Response to Submissions

For:
Proposed IKEA Multi-Function Logistics Unit and
associated Estate Civil and Infrastructure Works
SSD_6954

At:
Lot, 1, 3 and 4 in DP1208554, Lot 128, 132 in
DP1194052 and Lot 102 in DP1188147
Sydney Business Park – Marsden Park

November 2015

Figure 2.1: Site Plan/ Zoning Overlay

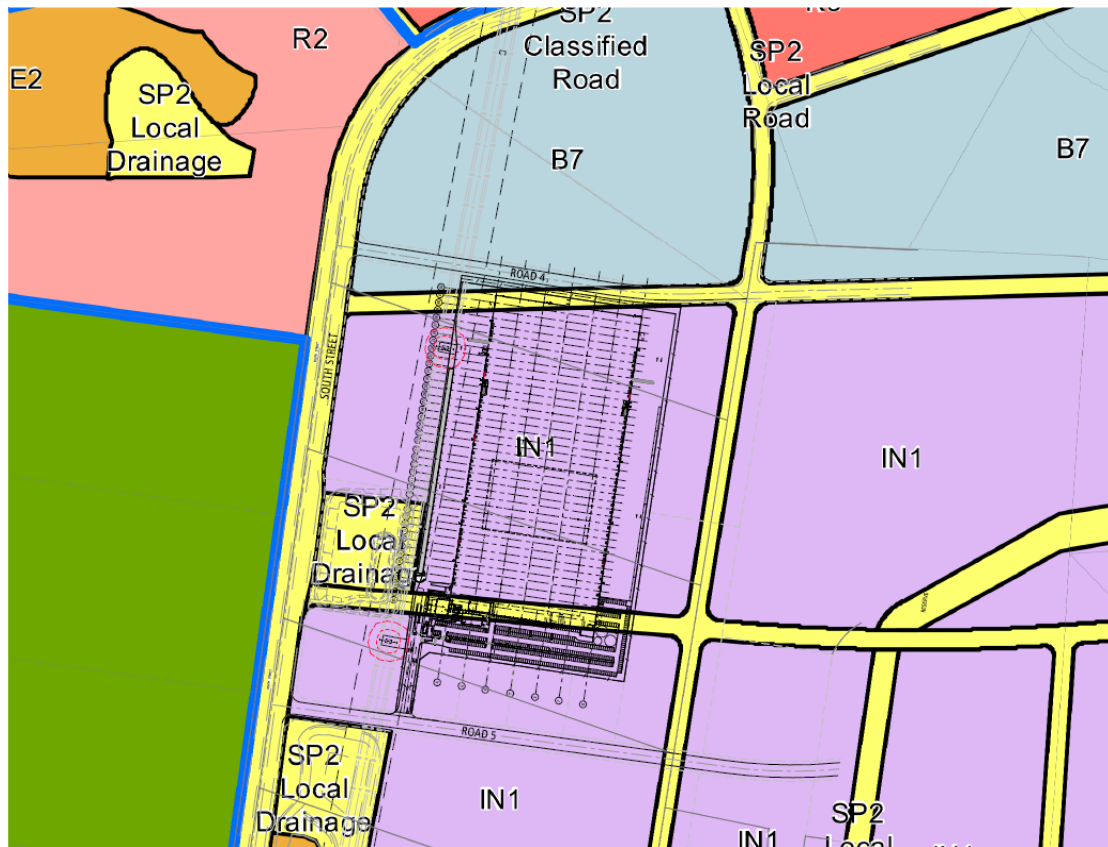
3 <i>As detailed in Council's correspondence dated 3 June 2015, it was identified that a portion of the subject site is zoned SP2 Infrastructure (Local Road) under State Environmental Planning Policy (Sydney Region Growth Centres) 2006. 'Warehouse and distribution centres' are not permissible in the zone. The EIS incorrectly states that the entirety of the site is zoned 'IN1 General Industrial.' We trust that the Department will address this zoning issue accordingly.</i>	The proposal involves varying the Indicative Layout Plan and therefore also the zoning map. The position of Road 4 and 5 are being modified to accommodate the proposal but retain the main functions of each road in providing east-west linkages through the Marsden Park Industrial Area. The road corridors will continue to comply with the visions of the DCP with regard to road design, width, building setbacks and all other amenity standards as outlined in the DCP. Further justification of the proposed modifications is provided in Section 2.1. In addition to this proposal, Blacktown City Council's strategic planning team is working closely with the Department of Planning and Environment to prepare a series of SEPP map adjustments throughout the North West Growth Centre to rectify and change existing mapping to reflect various proposals. The proposed changes to the Marsden Park Industrial Indicative Layout Plan are included as one of these

The matter of zoning was discussed at length with the Department prior to the submission of the Environmental Impact Statement. Initially, advice was provided by the Department that a Planning Proposal would need to be submitted to amend SEPP (Sydney Region Growth Centres) 2006, running concurrently with the Development Assessment process. This advice was later changed with confirmation being provided that the proposal need only change the Indicative Layout Plan, a process which would then automatically change the zoning layout. The Environmental Impact Statement was prepared on the basis of this advice. This is further confirmed by the fact that Blacktown Council and DoPE are working to update a series of maps that form part of the SEPP, one of which includes the proposed change.

It is therefore assumed that Blacktown City Council's concerns regarding the prohibition of 'Warehouse and distribution centres' within the SP2 Infrastructure (Local Road) are irrelevant where the proposal involves modifying the Indicative Layout Plan and therefore the position of zoning boundaries.

Figure 2.2: Proposed Estate Infrastructure Works overlayed with the current Marsden Park Industrial Indicative Layout Plan - shown in pink (Calibre Consulting 2015)

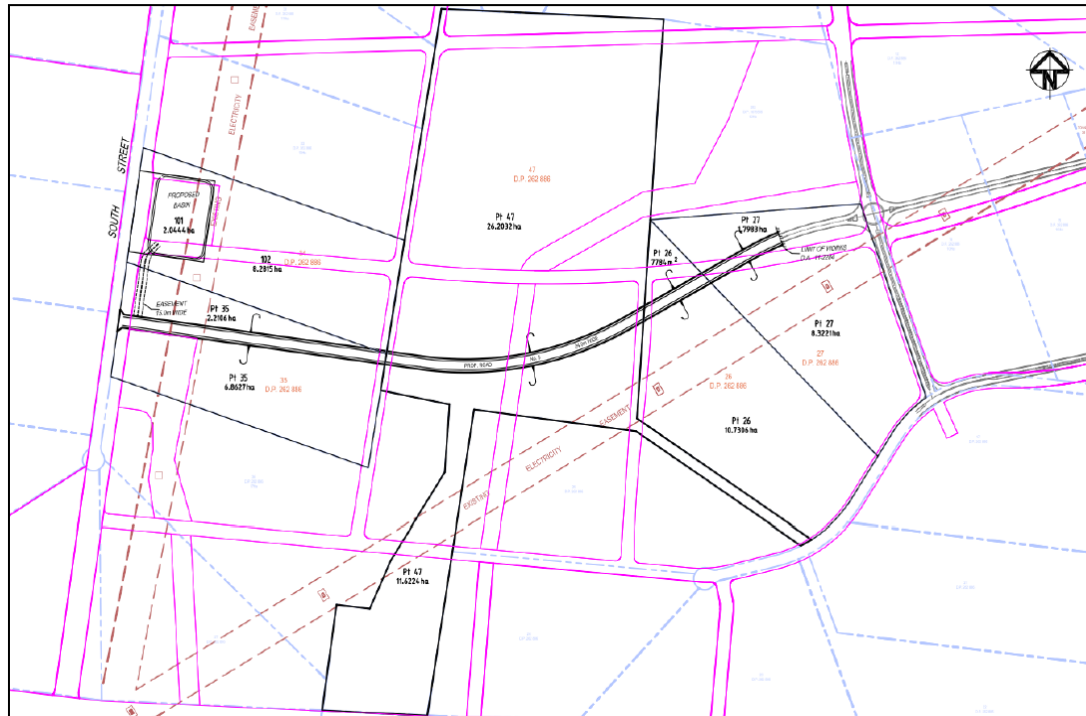
2 Indicative Layout Plan <i>The EIS states that the variation to the Marsden Park Industrial indicative layout plan (ILP) is being progressed with Council. However, DA15-1088 notes that compliance with the ILP will be addressed under future applications. Please confirm and provide details of any separate DA addressing variations to the ILP and civil works for the site. If the variation to the ILP is being sought under this application, please provide a justification for the departure from the ILP, consistent with the requirements of the Blacktown City Council Growth Centres Development Control Plan.</i>	The proposal involves varying the Indicative Layout Plan and therefore also the zoning map. The position of Road 4 and 5 are being modified to accommodate the proposal, whilst retaining the main functions of each road in providing east-west linkages through the precinct. The road corridors will comply with the visions of the DCP (regarding road design, width, building setbacks and all other amenity standards). Further justification of the proposal is provided below in Section 2.1. In addition to this proposal, Blacktown City Council's strategic planning team have been working with the Department of Planning and Environment to prepare a series of SEPP map adjustments throughout the North West Growth Centre to update existing mapping to reflect various proposals. The proposed changes to the Marsden Park Industrial Indicative Layout Plan are included as one of these modifications. FDC has been advised that Council will be issuing the

e) <i>The proposed lot layout plan appears to delete a zoned precinct road just east of the IKEA site. Confirmation is required that this is the case and appropriate DCP and SEPP amendments are completed in due course. If this road is not deleted in future then the size of the bio-retention in Basin B will need to be increased. The Design of basin B should allow for the additional road treatment area to ensure either case can be accommodated. The precinct planning results nominated a treatment area of 800m² instead of the 550m² in the current design.</i>	There is certainty that this zoned precinct road has been deleted, however, this does not form part of the current application. Future applications submitted by Sydney Business Park will address this issue.

The proposal involves repositioning the location of Road 4 and 5 to accommodate the length of the proposed MFLU in a north-south direction. The modification to Road 4 is less significant and involves relocating its future intersection with South Street further north (by approximately 50 metres). The modification to Road 5 is more significant, relocating its proposed intersection with South Street in a southerly direction by around 100 metres. Despite these changes, each road maintains its function by providing east-west linkages through the Marsden Park Industrial Area.

The attached estate civil engineering documentation (prepared by Calibre) illustrates that Road 5, in particular, will continue to comply with the visions of the DCP with regard to road design, reserve width and all other amenity standards as defined by the DCP.

Figure 4.18: Council Architectural suggestions for treating high bay warehouse

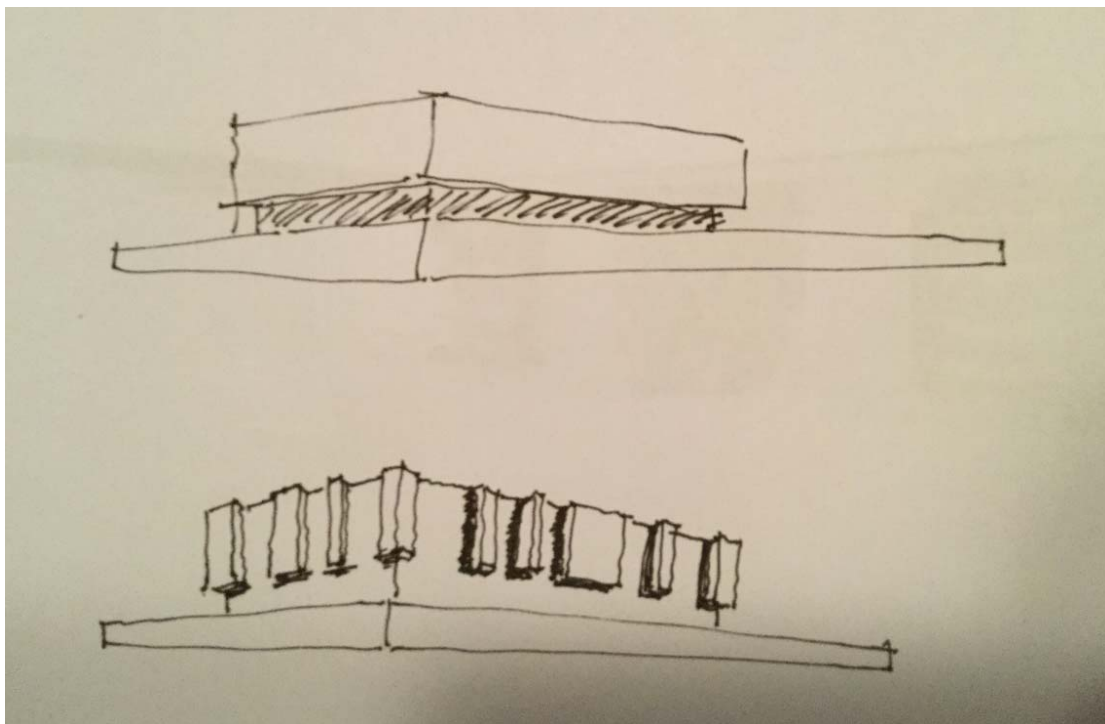
'The best way to articulate the building to change its visual appearance is to focus on the cube that sticks above the low, flat component. Given that it is safe to assume it has been designed to its minimum dimensions it will be a case of building the envelope out to cast some shadows.'

Two things worth trying are:

1. Creating a slot of about 6m (2 storeys) height at the junction of the cube and base by building out the upper portion of the cube by 1.5m or so to create a 3-part composition: base, recess and top. Onto this you overlay the patterning we talked about but keep the recess very dark in colour and use a light/dark random patterning to the top.
 2. Creating some vertical build outs at random widths and centres for the full height of the cube such that shadows are cast on the facade of the cube component. The build outs would be no less than 1.5m deep and varying widths of not less than 1.5m wide and up to 6m wide.
 3. A combination of 1 and 2 above.
- Preference in order is 3, 1, 2'

Despite the appeal of these options, they offer little help due to the limitations associated with automated high bay warehouse and the way in which it is designed and constructed. Furthermore, it is unlikely that option 1 would be visible from site or surrounding areas given its position, setback from the eaves of the standard warehouse.
